Access Compliance Report

Public Rights-of-Way

(Curb Ramps)

Intersection ID: 10023914	Main Street: CONFERENCE_DR	Cross Street: N/A	Location: NW
ADA ID: E9B3DE6ADA57	Ramp Type: Perp	Initial Pass/Fail: Fail	Overall Compliance: No
Severity Score: 13.75			
Codes/Mitigation Info/Possible Solution		Field Measurements/Component Compliance

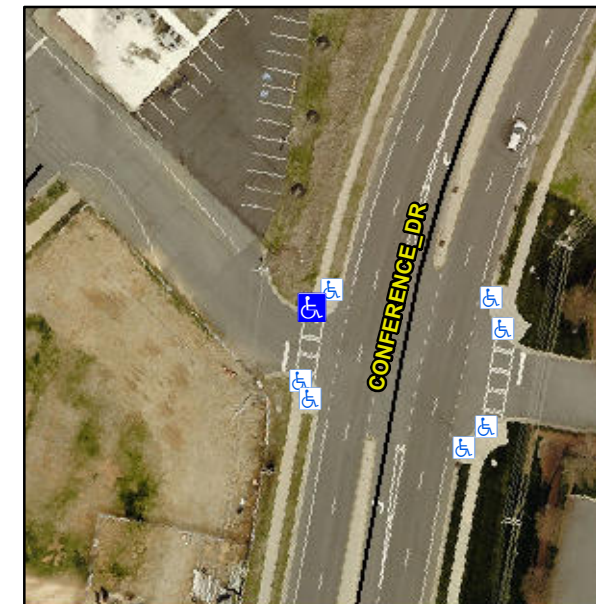
R304.2.2, R304.5.3

Compliance	Description	Data	Compliance	Description	Data
N/A	Ramp Length (in)	66.0	No	Ramp Slope (%)	9.0
Yes	Ramp Width (in)	48.0	No	Ramp XSlope (%)	5.0
N/A	Flare Type LT	N/A	N/A	Flare Type RT	N/A
N/A	Flare Slope LT (%)	N/A	N/A	Flare Slope RT (%)	N/A
N/A	Flare Traversable LT?	N/A	N/A	Flare Traversable RT?	N/A
N/A	Landing Length (in)	N/A	N/A	DWS Provided?	N/A
N/A	Landing Width (in)	N/A	N/A	DWS Contrast?	N/A
N/A	Landing Slope (%)	N/A	N/A	DWS Length (in)	N/A
N/A	Landing X Slope (%)	N/A	N/A	DWS Full Width?	N/A
N/A	Landing Curb? (Y/N)	N/A	N/A	DWS Offset (in)	N/A
N/A	Shared Landing?	N/A			
N/A	Gutter Ponding?	N/A	N/A	Gutter Slope (%)	N/A
N/A	Gutter Lip Ht (in)	N/A	N/A	Gutter X Slope (%)	N/A
N/A	Painted X Walk1?	Yes	N/A	Painted X Walk2?	N/A
	X Walk 1 Direction	To S		X Walk 2 Direction	N/A
N/A	X Walk 1 Width (in)	111.0	N/A	X Walk 2 Width (in)	N/A
	X Walk 1 Slope (%)	0.1		X Walk 2 Slope (%)	N/A
	X Walk 1 X Slope (%)	4.1		X Walk 2 X Slope (%)	N/A

Remove & Replace Entire Ramp.
